# UNITED STATES PATENT AND TRADEMARK OFFICE

APPLICATION NO.	FILING DATE	FIRST NAMED INVENTOR	ATTORNEY DOCKET NO.	CONFIRMATION NO.
10/643,878	08/20/2003	Kevin T. Foley	2165.0010003	5214

<b>Office Action Summary</b>	Application No. 10/643,878	Applicant(s) FOLEY ET AL.	
	Examiner Anu Ramana	Art Unit 3733

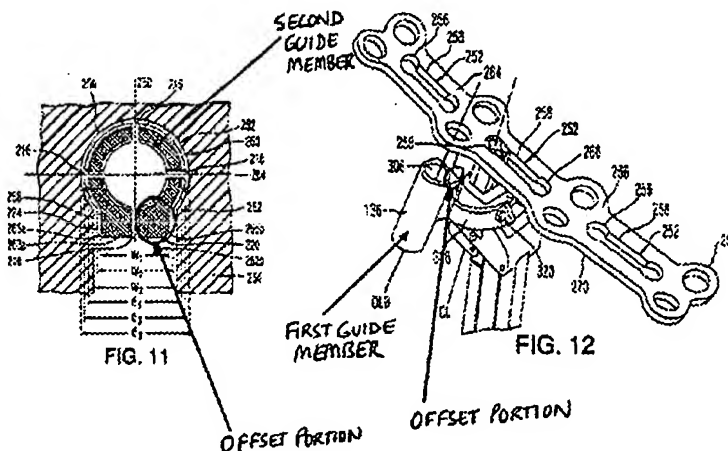
Brace et al. disclose a drill guide assembly for use with a bone plate to correctly seat screws in the bone plate, the assembly including: a first guide member 136 and a second guide member 206 extending from a handle 126; each of the guide members having an offset portion adjacent a distal end of the guide member; each of the guide members having a main body portion of a first width, an intermediate portion having a second width less than the first width, and the slot engaging end having a third end less than the second width; and wherein the guide members are configured and dimensioned to fit bone plate fastener holes having an elliptical shape (Figs. 1-2, 6 and 10-12 and cols. 5, lines 19-67 and cols. 6-14). See marked up Figs. 11 and 12 from Brace et al. below.

noted that edges 265a and 265b of the offset portions of Brace et al. are configured to contact an end of the slot (see Fig. 12). Notwithstanding this, it is noted that the limitation, "configured to contact said first end of said corresponding slot" only requires the capability of the offset portions to contact the first end of the slot and is not a positive limitation and does not constitute a limitation in any patentable sense.
